Initial Response to Public Comments from the June 8, 2021 Public Meeting

OPA-2021-02, ZBA-2021-02, SUB-2021-01

Shining Hill Estates Collection Inc. c/o Malone Given Parsons Ltd.

August 20, 2021

Figure 1: Before and after. Upon completion, this is now one of the largest underground stormwater detention systems in North America.

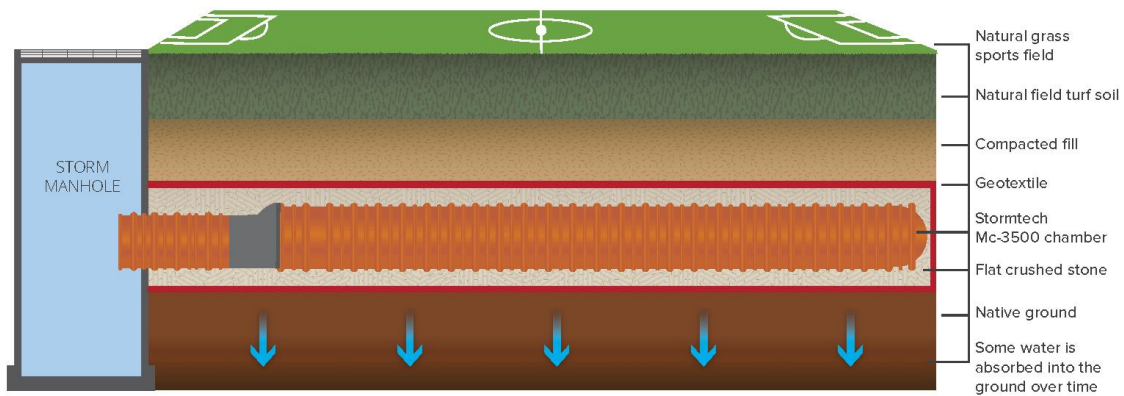
<p>13. Why can't we see the design of the stormwater cell?</p>	<ul style="list-style-type: none"> - Details regarding the stormwater management facility will be designed once the location has been settled. - Exemplary images follow.
<p>14. Slope Stability Report does not correlate to the Plan of Subdivision</p>	<ul style="list-style-type: none"> - The Slope Stability Report will be reviewed and confirmed during the next detailed submission stage. The draft plan of subdivision will be modified if

Examples of underground stormwater management facilities:
